NO.	DATE	REASON	BY
1	10/15/01	ADDENDUM #1	
2	10/26/01	ADDENDUM #2	
3	3/17/03	CP #19

PROJECT:
CHILD DEVELOPMENT
CENTER
CANADA COLLEGE
4200 FARM HILL BLVD.
REDWOOD CITY, CA 94061

SHEET TITLE:
DOOR AND FINISH
SCHEDULE/TYPES

DRAWN BY: *CC* PROJECT NO.: *304-99*
CHECKED BY: *JC* DATE: *3-14-03*
APPL. NO.: *103522* SHEET: *A0.1r*
DATA NO.: NO. OF:

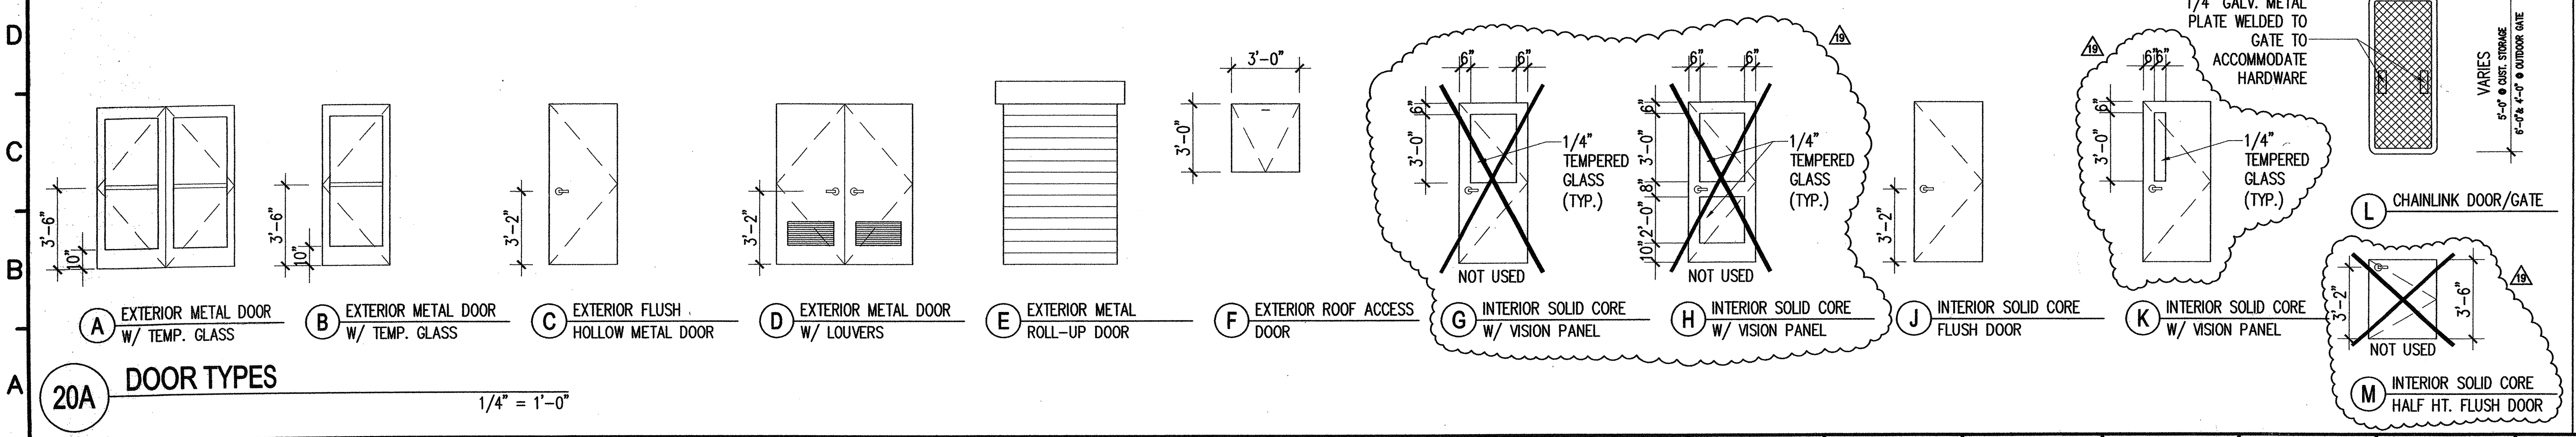
54	WOOD GATE		2X 3'-0"	6'-0"	12		WOOD STAIN		18E/SW2.1		GATE @ MECH. ENCLOSURE	
55	WOOD GATE		2X 3'-0"	6'-0"	12		WOOD STAIN		18E/SW2.1		GATE @ MECH. ENCLOSURE	
56	WOOD GATE		2X 3'-0"	6'-0"	12		WOOD STAIN		18E/SW2.1		GATE @ MECH. ENCLOSURE	
57											NOT USED	
58											NOT USED	
59											NOT USED	
60											NOT USED	
61	C	29A	3'-0"	7'-0"	7	20Q/A4.2	STEEL PAINT	8Q/A3.5	20K/A6.2	4Q/A3.5	SEE CHANGE REQUEST	
62	J	20	3'-0"	7'-0"	3	20Q/A4.2	STEEL PAINT	16A/A6.1	20E/A6.2	16A/A6.1

NOTE: SEE SHEET A0.2 FOR HARDWARE GROUP INFORMATION * CHANGE 60PD TO D50PD
